**TOWN OF MOUNTAIN VILLAGE
SPECIAL DESIGN REVIEW BOARD MEETING AGENDA
MONDAY JULY 14, 2025, 10:00 AM
MOUNTAIN VILLAGE TOWN HALL
455 MOUNTAIN VILLAGE BLVD, MOUNTAIN VILLAGE, COLORADO
TO BE HELD HYBRID THROUGH ZOOM:**

RE: Staff Memo – Review and Recommendation to Town Council for a Conditional Use Permit for a Spider Jump Activity and Zipline Ground School at Lot OS-3U, pursuant to CDC Section 17.4.14.

APPLICATION OVERVIEW: Conditional Use Permit for Spider Jump Activity and Zipline Ground School on Lot OS-3U

To: Daniel Alvarado, Senior Planner
From: Amy Ward, Community Development Director
Re: Conditional Use permit Application, Temporary Surface Parking, Lots 122 and 123 and OS 1R2
Date: July 1, 2025

Parking Plan

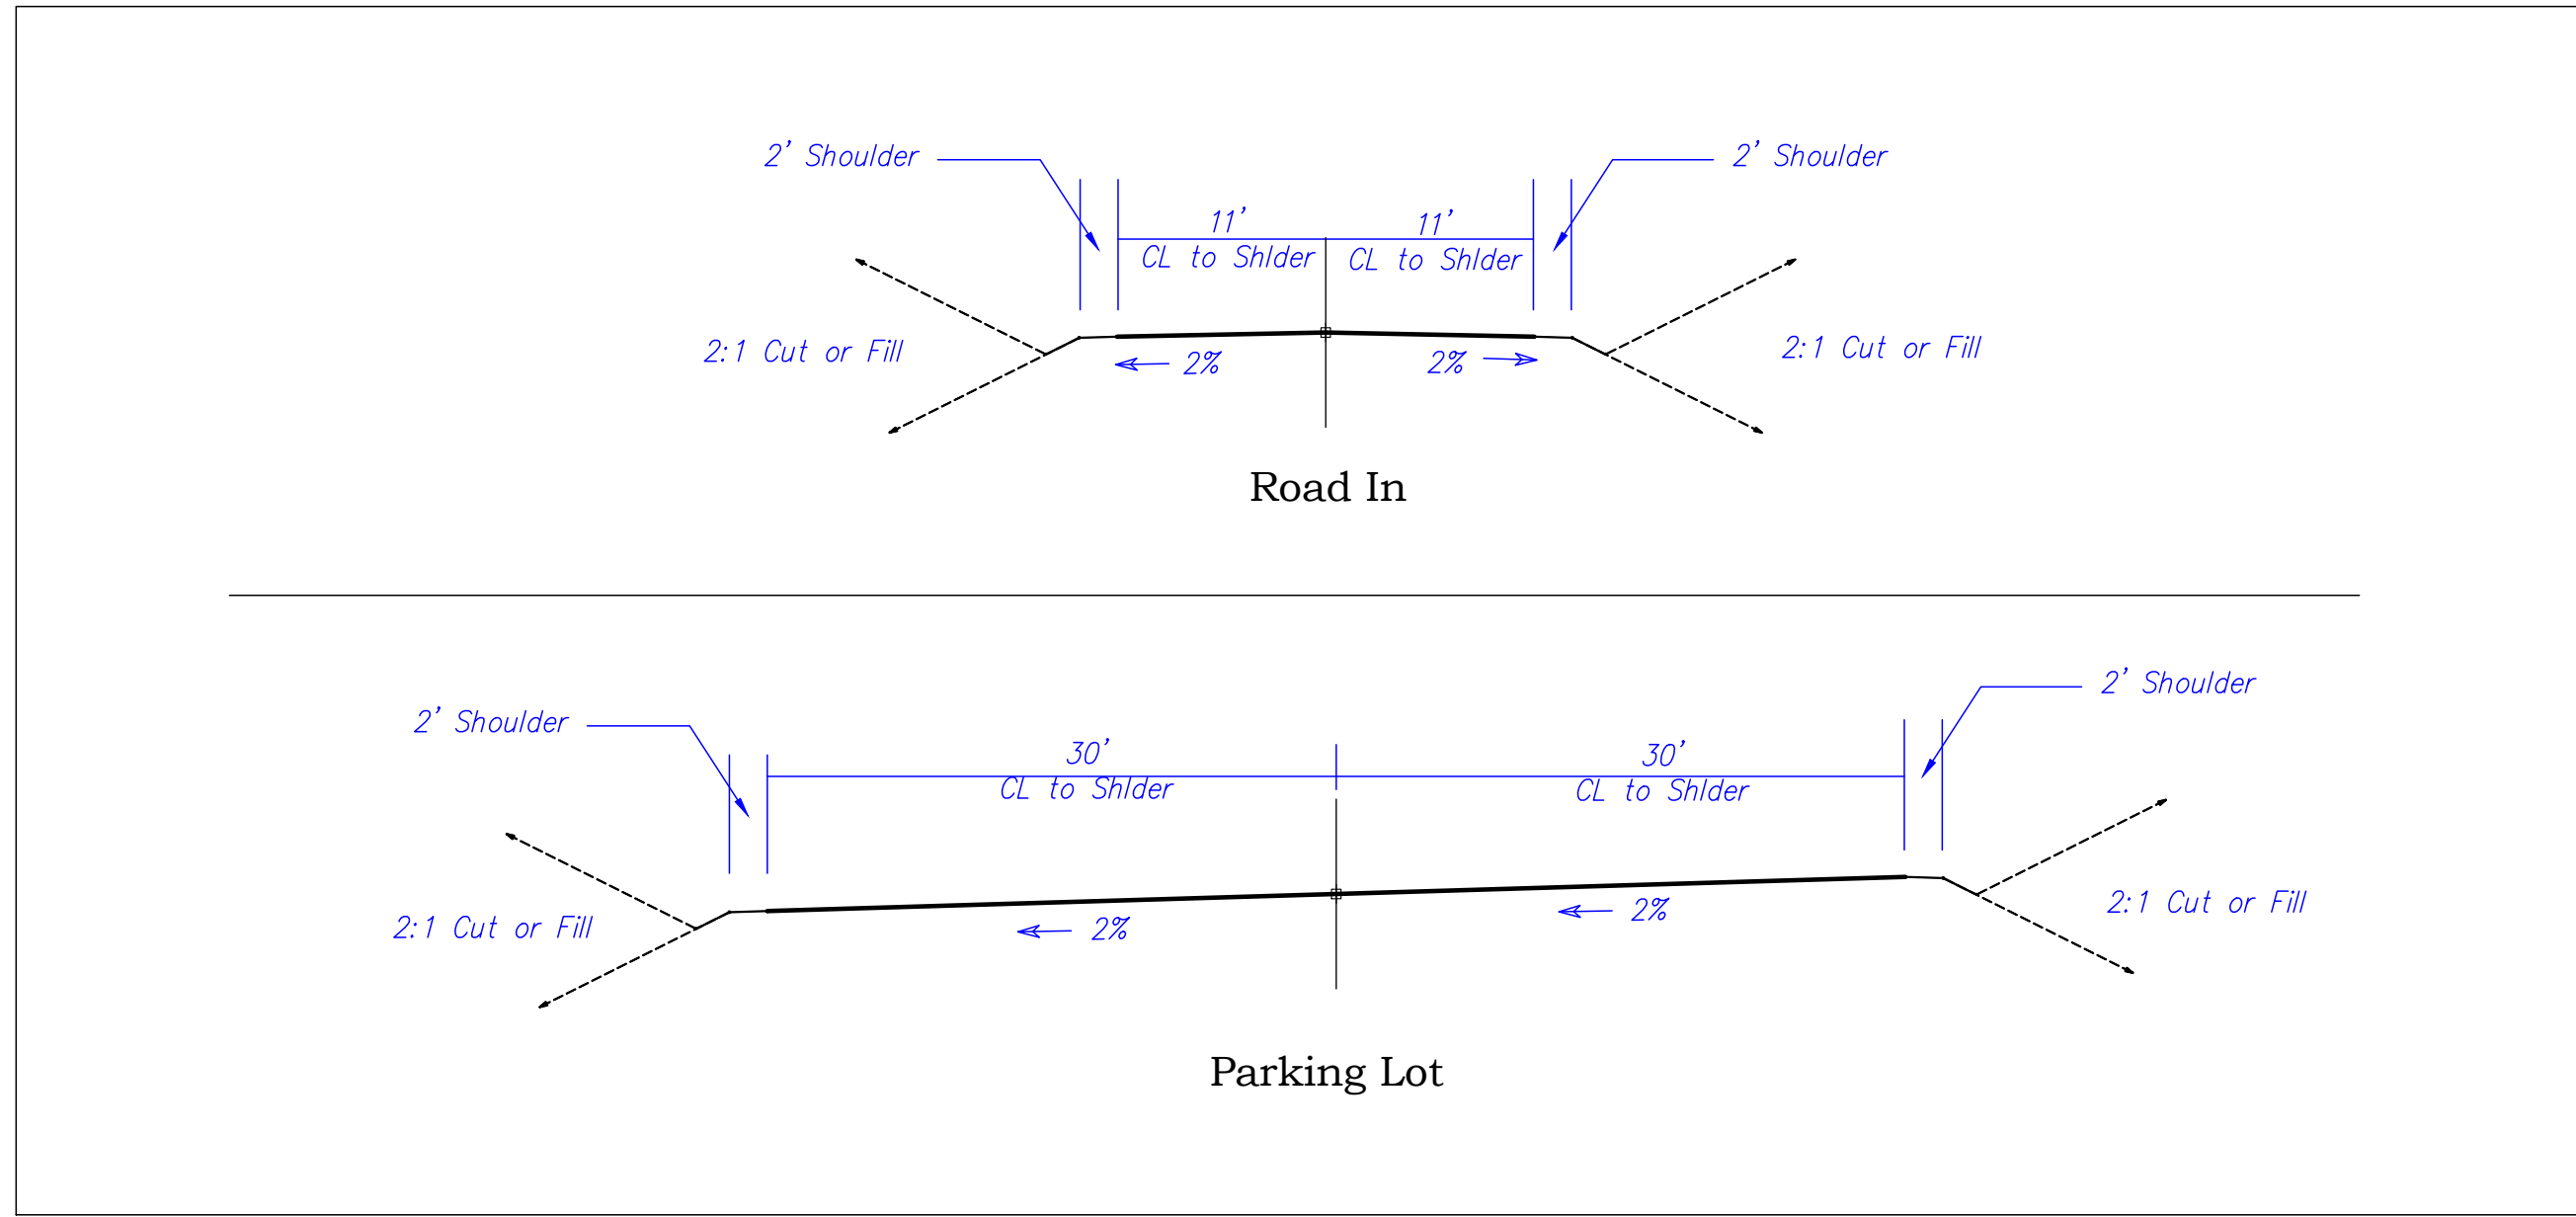
parking space geometry, therefore the applicant shall be required to provide such details as a condition of approval.

Typically, applicants are required to provide a detailed striping and signage plan. The applicant has not provided a striping or signage plan, only a written description of “signage specifying that the parking area is for TSG Employees...proposed as 1’x2’ sign located at the entrance to the parking area with simple lettering and the TSG Logo”.

7)	Provide additional driveway details including shoulder material and grade	Planning	Prior to development permit
8)	Provide additional parking lot geometry details including space size and aisle width, etc.	Planning	Prior to development permit

Irrigation

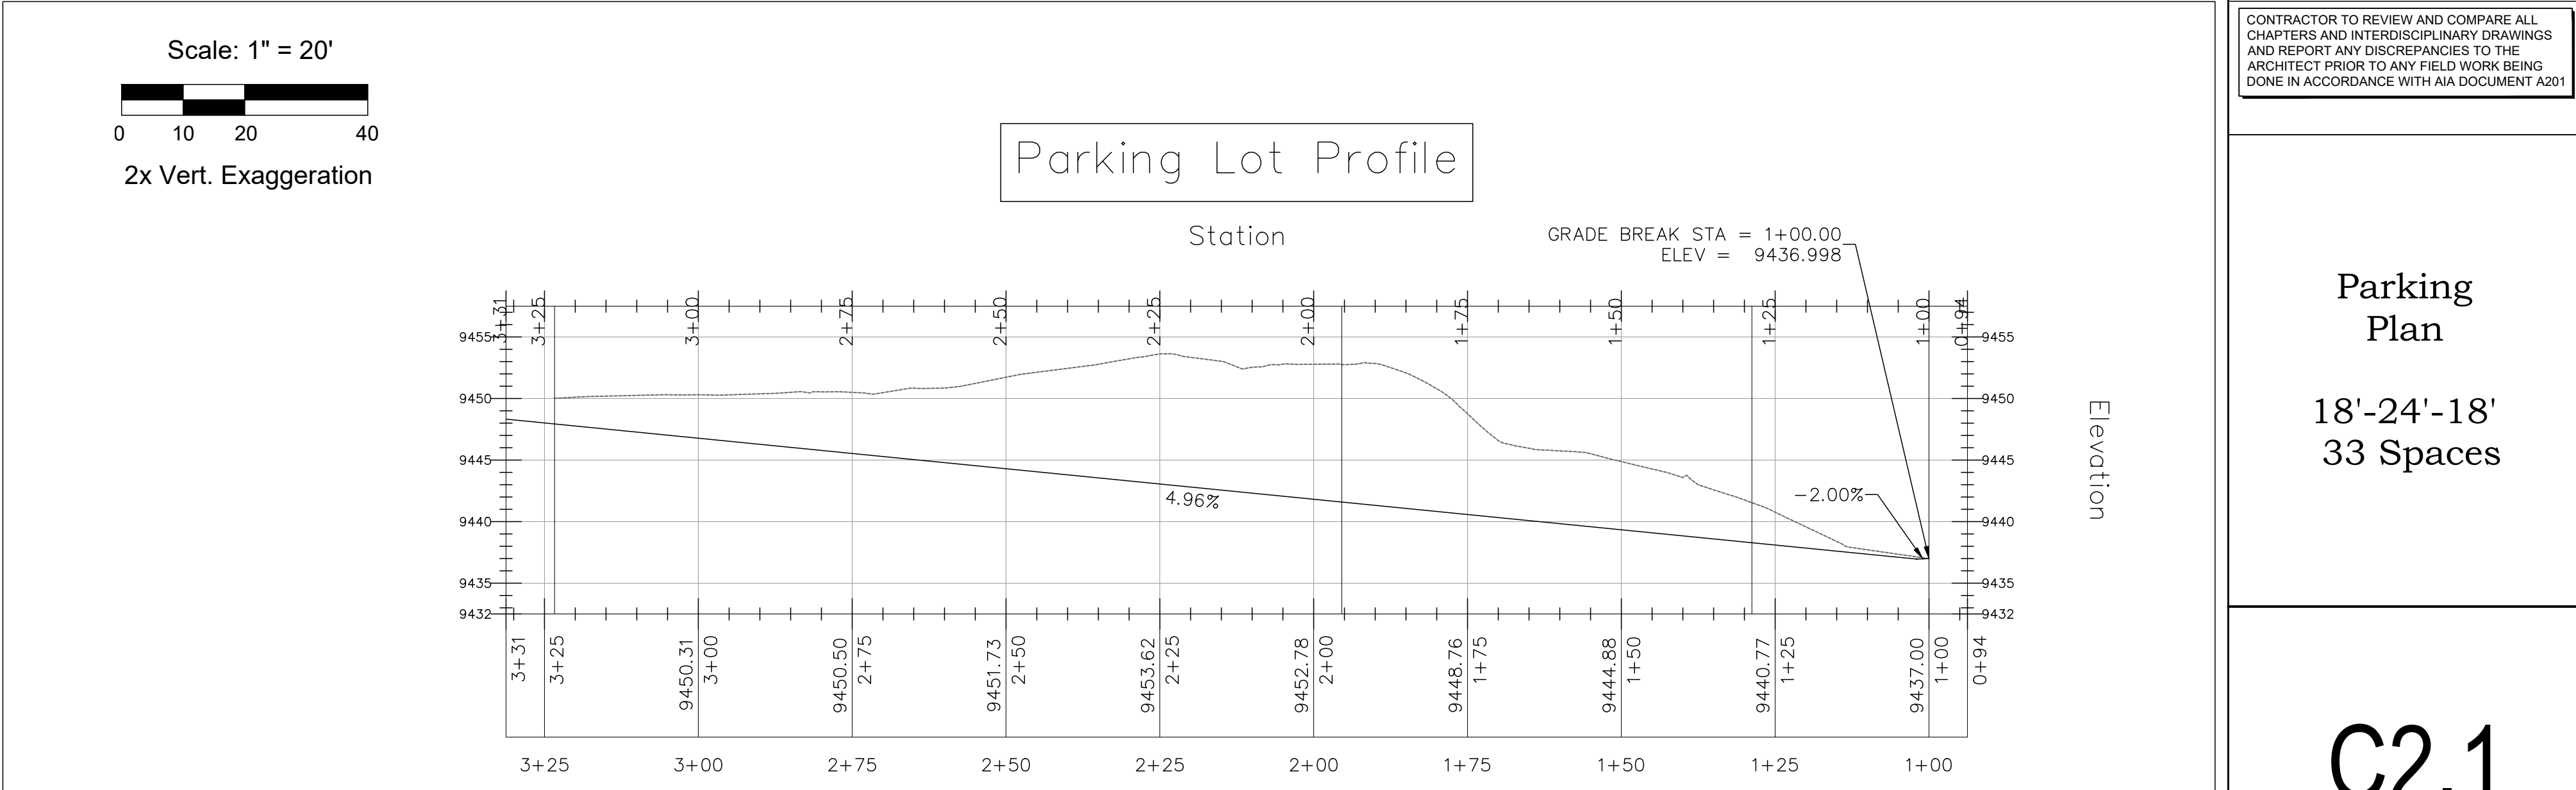
The applicant has proposed landscaping around the perimeter of the parking lot depicting the planting of 17 trees including aspen, spruce and dwarf pines. The landscaping would be irrigated by a sprinkler system that would be installed around the perimeter of the parking lot. The applicant has not provided details regarding the trees to be removed as part of the proposed development.

g. The design, development and operation of the proposed conditional use shall provide adequate infrastructure.	Criterion Met: (Yes/No) NO
The applicant has not provided sufficient details regarding the improvement of pedestrian infrastructure to safely access the site. The applicant has not provided sufficient details regarding the origin of water for the irrigation system.

#	Condition of Approval/Note	Department or Division	Completed By:
1)	Applicant shall provide additional details required regarding the origin of the water for the irrigation system	Planning	Prior to development permit
